Product Change Notification / MFOL-28NMYX712

CCB 5167 Final Notice: Qualification of MMT as an additional assembly site for selected MCP2561 and MCP2562 device families available in 8L DFN (3x3x0.9mm) package.

**CCB 5167**  
**Pre and Post Change Summary**  
**PCN# MFOL-28NMYX712**

## NSEB

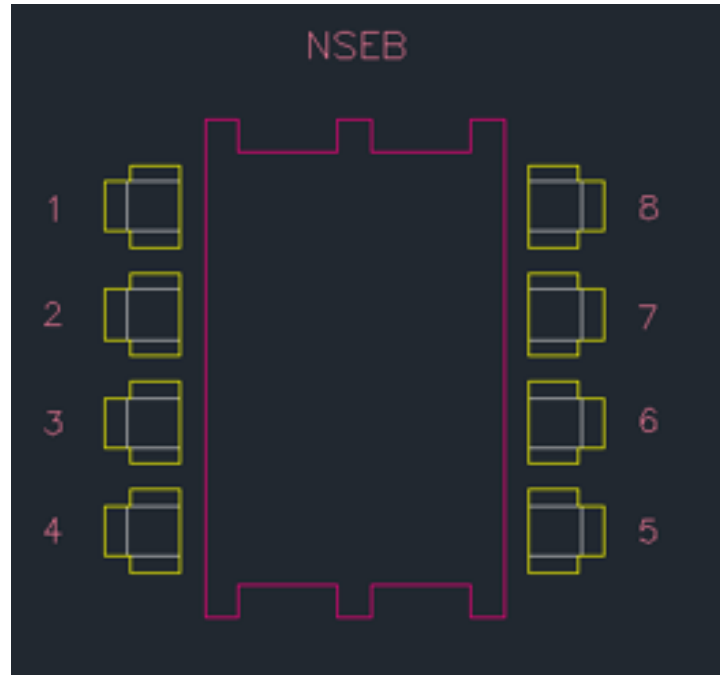
Lead-lock

No

## MMT

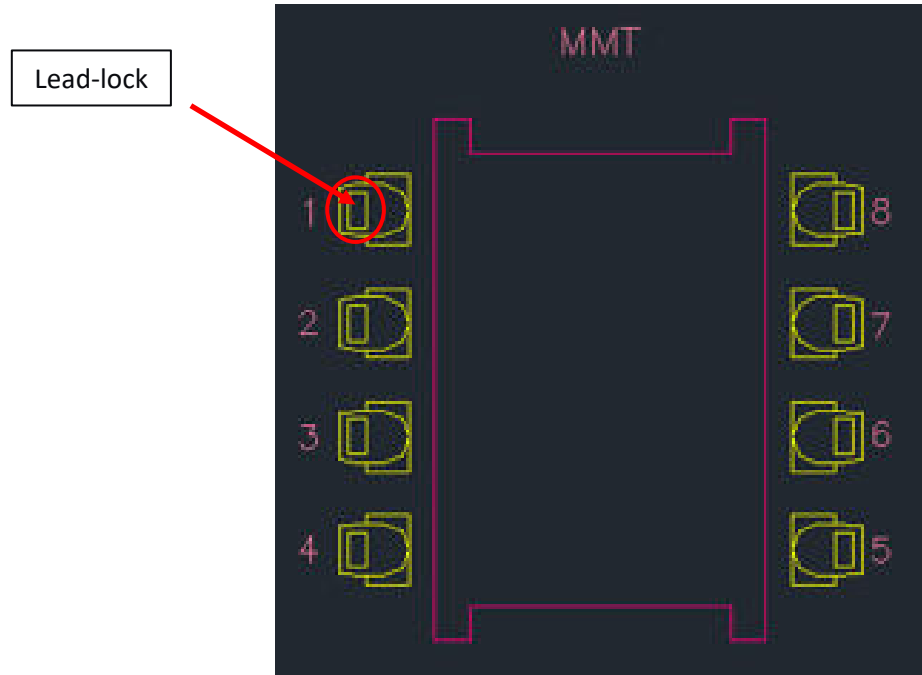
Lead-lock

Yes

Note: Mold compound material fills the lead-lock hole, which provides improved protection against moisture penetration along the edge of the leads (pins) of the package.
